SERVICE BULLETIN

CESSNA / CITATION II

SB550-57-2

AILERON FENCE REPLACEMENT

VIEW LOOKING DOWN
 Aileron Fence Replacement
 Figure 1

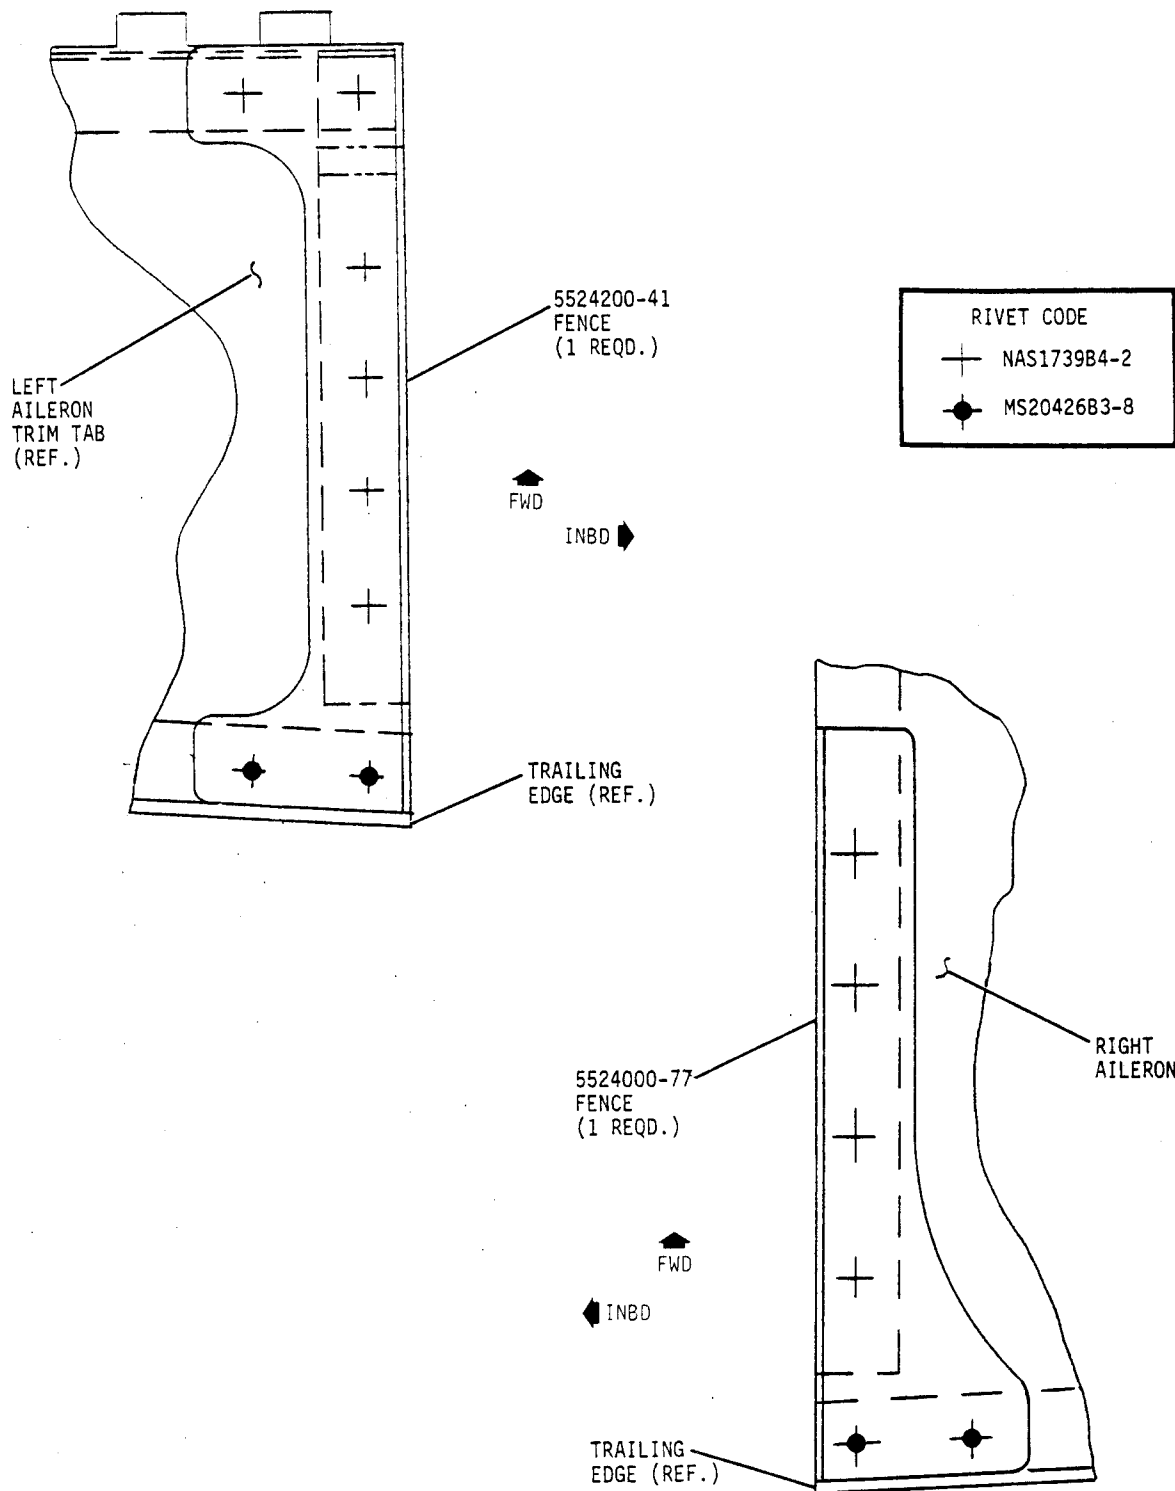
This bulletin provides parts and instructions for replacing the existing aileron fences with new, taller fences.

3. (See Figure 1) Place and clamp the 5524000-77 Fence in position and back drill (.098) diameter holes thru the fence (2 places) using the existing holes in the aileron trailing edge. Use temporary sheet metal fasteners at these two locations.

4. Using a hole finder, locate the other four (4) holes and drill (.140) diameter thru the fence (4 places). Deburr all holes in the fence.
5. Repeat Steps 2 thru 4 for the left aileron trim tab and the 5524200-41 Fence.

7. Apply a thin coating of sealer from the MIL-S-8802 Semkit to the faying surfaces and install the 5524000-77 Fence (LH Aileron Trim Tab) and 5524200-41 Fence (RH Aileron) using MS20426B3-8 and NAS1739B4-2 Rivets as shown.
